PLANNING COMMISSION AGENDA
COEUR D'ALENE PUBLIC LIBRARY
LOWER LEVEL, COMMUNITY ROOM
702 E. FRONT AVENUE

MAY 22, 2012

TO: Planning Commission
FROM: Christopher H. Bates, Engineering Project Manager
DATE: May 22, 2012
SUBJECT: **SS-6-12, Riverstone West 4th Addition**

FROM: TAMI A. STROUD, PLANNER
DATE: MAY 22, 2012
SUBJECT: PUD-2-94 M5 – MODIFICATION OF COEUR D'ALENE PLACE PUD
S-3-12 MODIFICATION OF COEUR D'ALNE PLACE PRELIMINARY PLAT.
LOCATION: +/- 706 ACRES KNOWN AS THE COEUR D'ALENE PLACE PUD

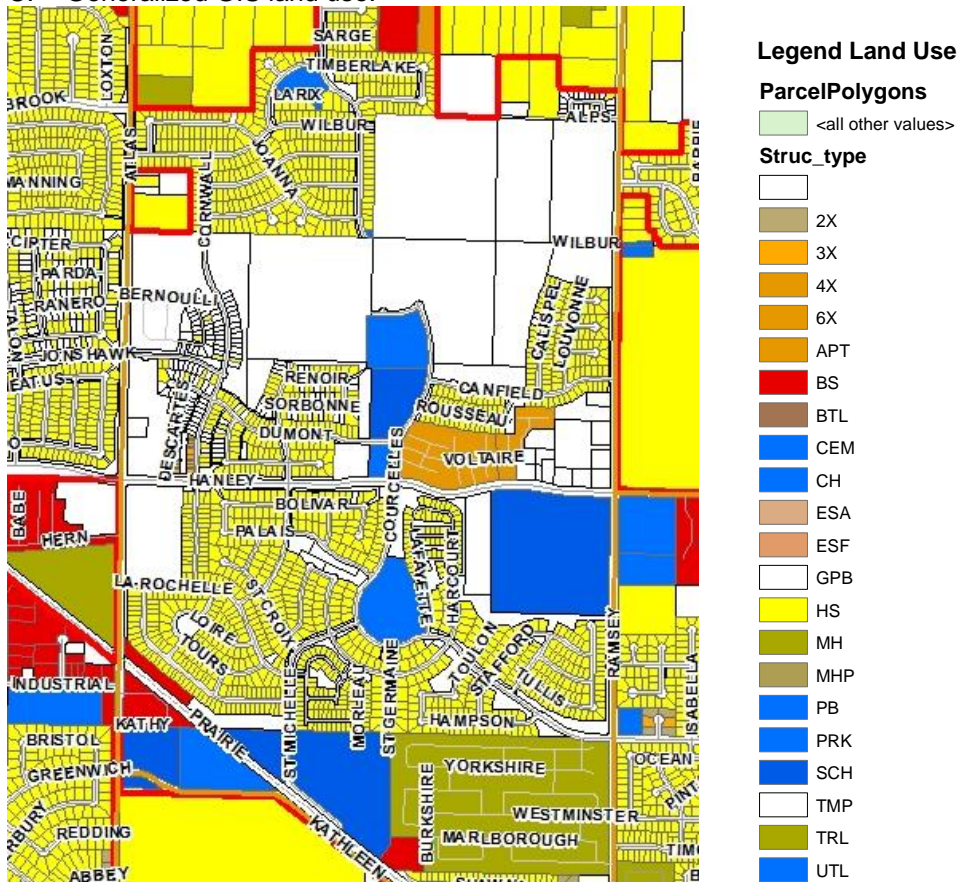
The applicant has provided a trail map that provides connectivity throughout the development.

Evaluation: The Planning Commission must determine, based on the evidence before them, whether the Comprehensive Plan policies do or do not support the request. Specific ways in which the policy is or is not supported by this request should be stated in the finding.

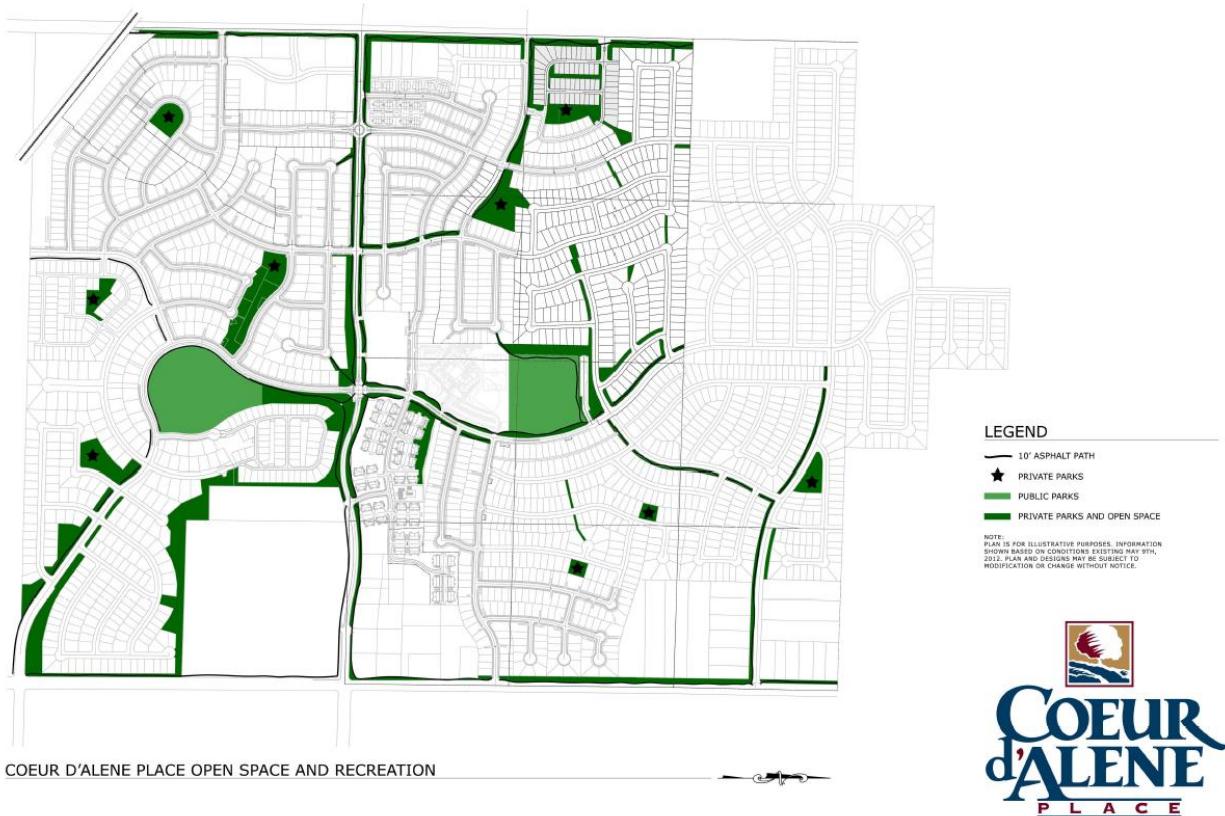
Finding #B11: D. The location, design, and size of the proposal are such that the development will be adequately served by existing streets, public facilities and services.

1. In "cluster" areas that have lot frontages reduced to twenty feet (20'), no frontal vehicular access will be allowed. All access to reduced frontage lots must be rear entry.
2. SEWER- Public sewer is available and of adequate capacity to support this PUD modification
EVALUATION- Sewer utility review finds that this application follows the 2005 Northwest Quadrant Sewer Master Plan.

Evaluation: The Planning Commission must determine, based on the evidence before them, that public facilities and utilities are or are not available and adequate for the proposed use.
